**Review of “Spatial variability and future evolution of surface solar radiation over Northern France and Benelux: a regional climate model approach”**

**by Gabriel Chesnoiu, Isabelle Chiapello, Nicolas Ferlay, Pierre Nabat, Marc Mallet, and Véronique Riffault**

Dear Referee #2,

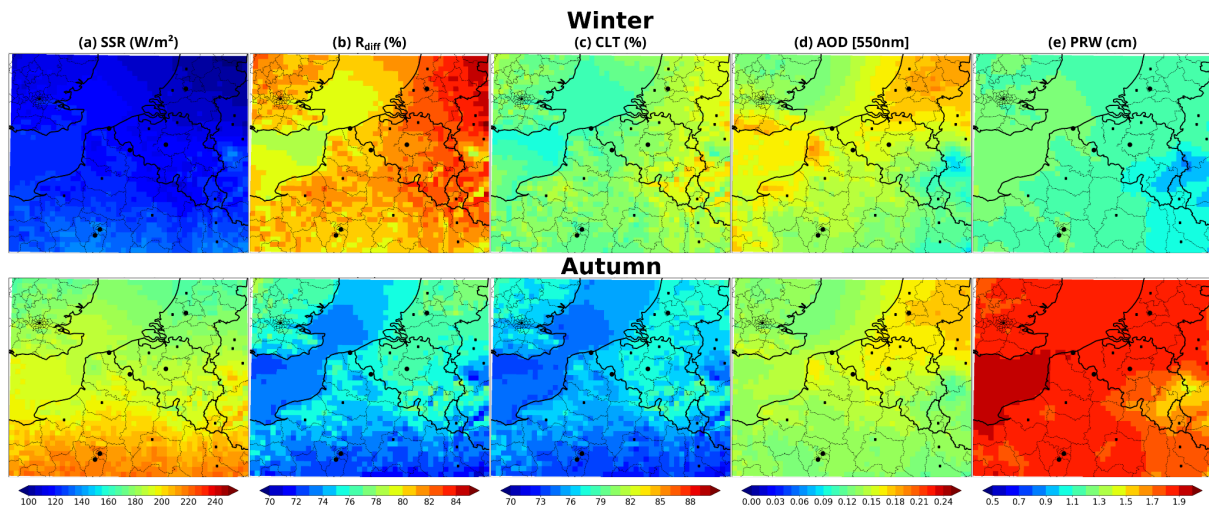
***It is understandable the need to deepen the analysis for Spring and Summer seasons for the spatial variability analysis. However, including the analysis illustrated in Figure 7 for Autumn and Winter will enrich the overall analysis and further interpretation with Figure 3 and Figure 4a.***

In response to the referee’s comment the following figure has been added to the supplements (Fig. S7 of the revised manuscript).

In addition, a few comments have been included in the main text of Section 4.1 (see lines 483-489) to highlight similarities and discrepancies between spring/summer seasons (previously Fig. 7, now Fig. 8) and winter/autumn (Fig. S7).

“Corresponding simulations of the spatial variability of SSR and associated atmospheric parameters for winter (i.e. December-January-February) and autumn (i.e. September-October-November) seasons are reported in the supplements (Fig. S7). For these two seasons, the spatial patterns are similar to those observed in spring and summer (Fig. 8). However, as expected, AOD ranges are significantly reduced over most of the BNF region, together with increased simulated CLT levels, from 72% to more than 80%. Simulated SSR are largely reduced, below 150 W.m<sup>-2</sup> in winter, and 220 W.m<sup>-2</sup> in autumn. Thus, in order to evaluate the impacts of contrasted anthropogenic aerosol future emissions on the high-end range of SSR, we will focus on spring and summer seasons.”
